Access Compliance Report

Public Rights-of-Way

(Curb Ramps)

Intersection ID: 14373	Main Street: EAST_BV	Cross Street: LYNDHURST_AV	Location: SW
ADA ID: 006664323A33	Ramp Type: Directional1	Initial Pass/Fail: Fail	Overall Compliance: No
Codes/Mitigation Info/Possible Solution		Field Measurements/Component Compliance	
Severity Score: 12.5

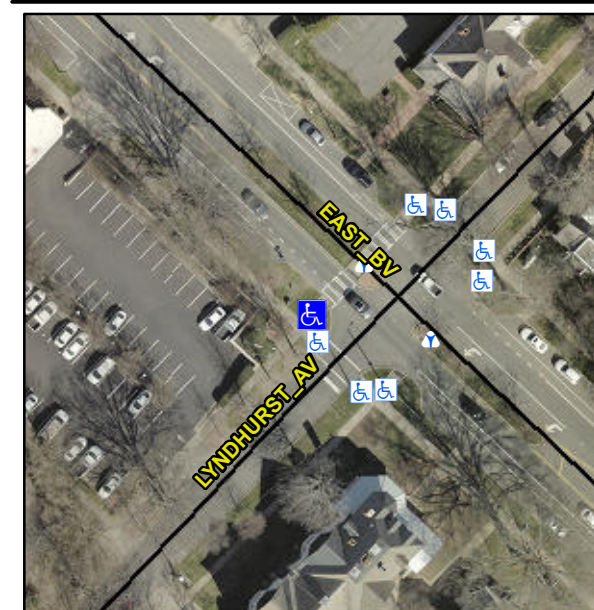
Compliance	Description	Data	Compliance	Description	Data
N/A	Ramp Length (in)	66.0	N/A	Grade Break?	N/A
Yes	Ramp Width (in)	72.0	N/A	Grade Break Slope (%)	0.0
Yes	Ramp Slope (%)	3.6	N/A	Grade Break XSlope (%)	0.0
No	Ramp XSlope (%)	5.8			
N/A	Flare Type LT	N/A	N/A	Flare Type RT	N/A
N/A	Flare Slope LT (%)	N/A	N/A	Flare Slope RT (%)	0.0
N/A	Flare Traversable LT?	N/A	N/A	Flare Traversable RT?	N/A
N/A	Landing Length (in)	0.0	N/A	DWS Provided?	N/A
N/A	Landing Width (in)	0.0	N/A	DWS Contrast?	N/A
N/A	Landing Slope (%)	0.0	N/A	DWS Length (in)	N/A
N/A	Landing X Slope (%)	0.0	N/A	DWS Full Width?	N/A
N/A	Landing Curb? (Y/N)	N/A	N/A	DWS Offset LT (in)	N/A
N/A	Shared Landing?	N/A	N/A	DWS Offset RT (in)	N/A
N/A	Gutter Ponding?	0.0	N/A	Gutter Slope (%)	N/A
N/A	Gutter Lip Ht (in)	0.0	N/A	Gutter X Slope (%)	N/A
N/A	Painted X Walk1?	Yes		Road Slope (%)	5.6
	X Walk 1 Direction	To NE		Road X Slope (%)	0.8
	X Walk 1 Width (in)	112.0		Clear Space?	N/A

X Walk 1 Slope (%)	5.6	N/A	Clear Space to XWalk (in)	N/A
	X Walk 1 X Slope (%)	0.8	N/A	Storm Grate/Utility Hazard?	N/A
N/A	Ramp inside XWalk1?	Yes		Storm Grate/Utility Type	
N/A	Any Obstructions?	N/A			N/A
	Obstruction Type		Yes	Surface Condition? (G/P)	Good
			N/A	Curb Slope (%)	3.7

Remove & Replace Entire Ramp.

R304.5.3
